To: Zina Ainsworth At: Tahmoor Coal  
From: Maxime Philibert/ Will Minchin At: SLR Consulting Australia Pty Ltd  
Date: 23 September 2021 Ref: 665.10010.00507-M01-v3.0-20210923.docx  
Subject: IAPUM Advice re: North Western Domain Longwalls W3 and W4 Extraction Plan  
Response to Groundwater Recommendations

Figure 1 Site SB – Inferred Groundwater Level and Measured Surface Water Level

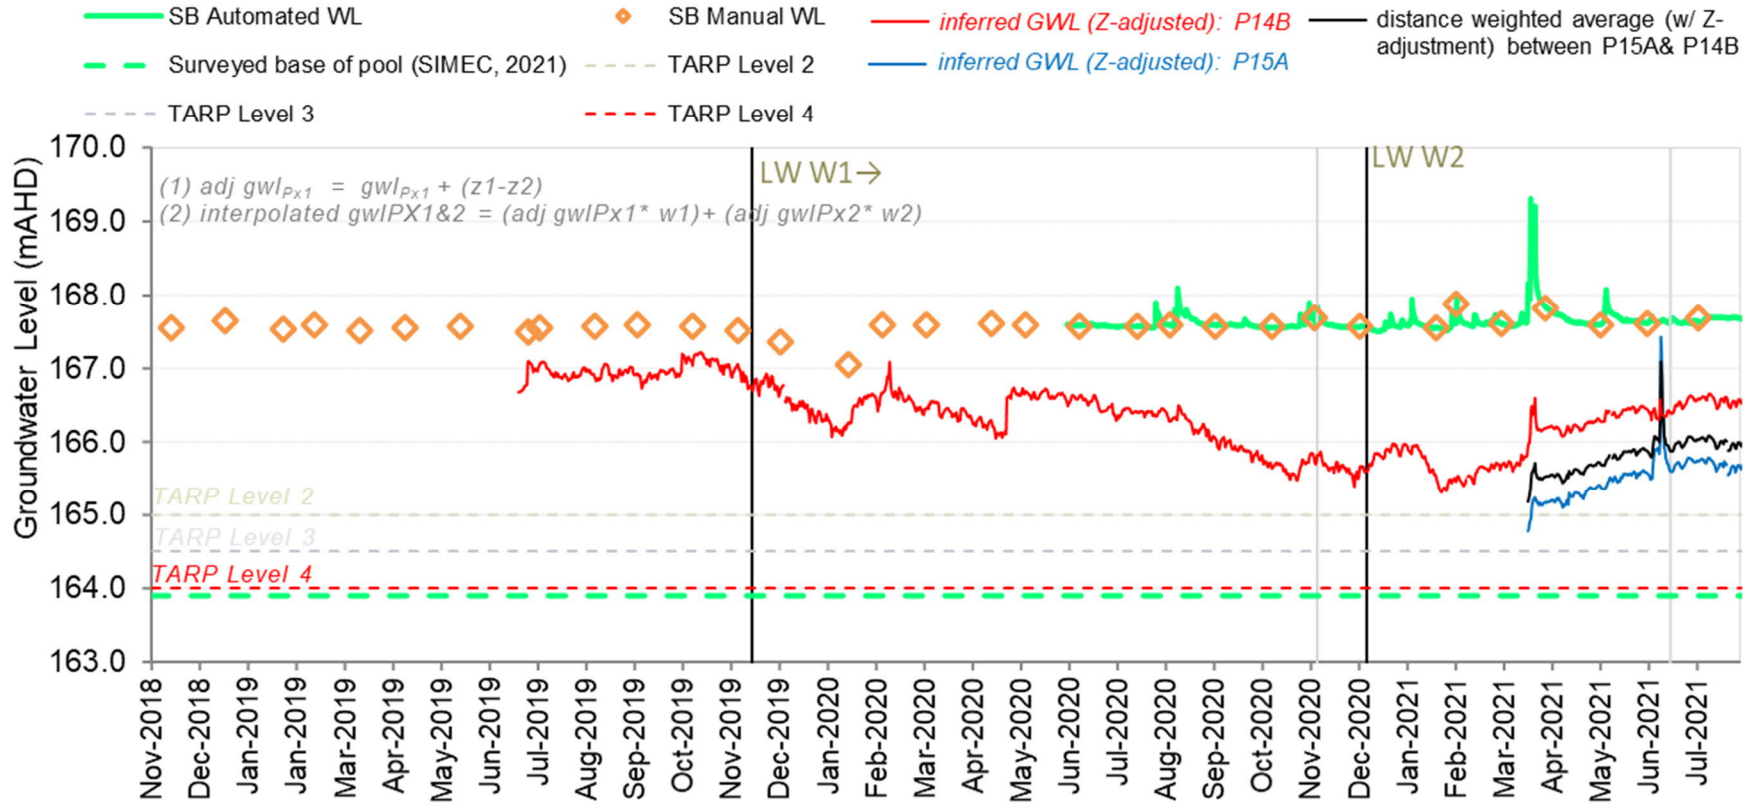
Loss of baseflow at rockbar SR17 that is not associated with visible fracturing or subsidence movement is not captured under the proposed performance indicators for Surface Water and Groundwater Resources or in the proposed indicators for Aboriginal and heritage sites.

The Panel considers that mining-induced baseflow loss which causes visible reductions to water levels of pools adjacent to the grinding groove sites may lead to the performance measure of negligible environmental consequences not being met. This is not something that can be fully addressed by the Management Plan for SR17 due to the potentially long time-lags between baseflow and extraction.

The subsidence performance indicators relating to the performance measure “Negligible subsidence impacts or environmental consequences” should cover the possibility of mining-induced baseflow losses at SR17. A suitable additional performance indicator would be: *This performance measure will be considered to be exceeded if mining impacts lead to a cessation of flow over the SR17 rockbar.*

Groundwater site P14 is 170 m west of site SB, while P15 is 90 m to the south of SB, and therefore closer to LW W3. The base of the pool at SB was surveyed by SIMEC (2021) at 163.9 mAHD. Inferred groundwater levels, using the distance weighted average (with Z-adjustment) method (black series on Figure 1), at SB are estimated to be 2 m above the base of pool, however are 1.8 m below recorded pool water level suggesting losing conditions during May-July 2021 (SLR, 2021a; SLR, 2021b). Despite the apparent losing conditions, the basis for the proposed TARP is that groundwater (as measured at P14B and P15A) is more likely to support baseflow to Stonequarry Creek whilst groundwater levels are above the base of the pool (163.9 mAHD) (SLR, 2021b).

The TARP levels proposed to monitor and assess the potential for mining-related baseflow loss were developed using the base of the pool as the point for comparison. The TARP Level at SB was calculated as the follows:

- TARP Level 2 = base of the pool [mAHD] + 1.1m = 165.0 mAHD.
- TARP Level 3 = base of the pool [mAHD] + 0.6 m = 164.5 mAHD.
- TARP Level 4 = base of the pool [mAHD] + 0.1 m = 164.0 mAHD.

Figure 1 presents these proposed TARP Levels (Levels 2, 3 and 4) in comparison with the base of the pool.

TARP Level 2 is proposed at 165.0 mAHD, which is approximately 0.3 m below the inferred minimum groundwater level using the black series (165.3 mAHD), and below the recent (August-2021) groundwater level. TARP Level 2 is designed to inform whether the groundwater level at (beneath) SB has declined to a level that is similar to the previous minimum groundwater level inferred during extraction of LW W2.

TARP Level 3 and 4 are designed to inform Tahmoor Coal and the Technical Committee that inferred groundwater levels have declined to approximately 0.6 m and 0.1 m above the base of the pool and provide progressive signs that potential baseflow discharge to Stonequarry Creek has reduced in magnitude or will do so. This has been proposed in order to address the issue identified by IAPUM regarding baseflow loss *in the absence* of measurable ground movement (e.g. valley closure), where subsidence and ground movements are addressed in the SCRMP (Tahmoor Coal, 2021b). We note that effects on surface water flows at site SB are already monitored and assessed on a monthly basis by Tahmoor Coals' consultant hydrologists.

These TARPs are proposed above the base of the pool at SB due to the likely time-lags between panel extraction and baseflow loss. It aims to give sufficient time for Tahmoor Coal and the Technical Committee to appropriately respond before inferred groundwater levels decline below the base of the pool at SB which in turn influences the groundwater-surface water interactions along this section of Stonequarry Creek.
